Re: Saint Simons Christian School Rezone, ZM-24-15 and 1060 Coquina Circle Site Plan, SP-24-17

Re: GORA Request Regarding Unaddressed Deficiencies in the Revised Drainage Report for Sea Island Team Member Housing by Robert's Civil Engineering, dated December 4, 2023

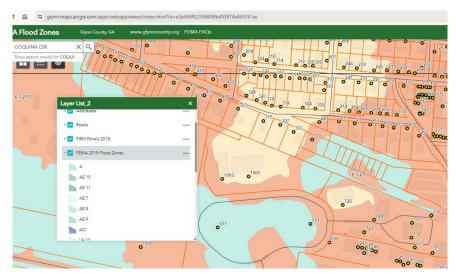
The rezoning amends Tract C of the Old Stables PDD to add school facilities, a gymnasium, and recreational fields and infrastructure to the mixed commercial uses zoning. These uses include facilities and parking lot area(s) within the Flood Zone AE-8 (as shown in the excerpt from the Glynn County's Federal Emergency Management Agency Flood Zones map below) with no indication of how the facilities would comply with the County Flood Protection Ordinance Section 2-5-139 Standards for Areas of Special Flood Hazard (Zones AE) with Established Base Flood Elevations and without Designated Floodways. Section 2-5-139 states "no encroachments, including fill material, new structures or substantial improvements shall be located within areas of special flood hazard, unless certification by a registered professional engineer is provided demonstrating that the cumulative effect of the proposed development, when combined with all other existing and anticipated development, will not increase the water surface elevation of the base flood more than one foot at any point within the community. The engineering certification should be supported by technical data that conforms to standard hydraulic engineering principles."

- According to County Ordinance Section 2-5-137(d), areas of special flood hazard must be free from encroachment in order to allow for the discharge of the base flood without increasing the flood heights. In order to meet this requirement, there must be a hydrologic and hydraulic analysis of the encroachment in the floodway. Since the Site Plan proposes the removal of existing vegetation and construction of approximately 24,572 square feet of new buildings and additions and there will be fill placed without a flood analysis, the County cannot be assured site development will not exacerbate the existing flood issues known by County staff. This analysis must be completed before preliminary plan approval of the Site Plan.
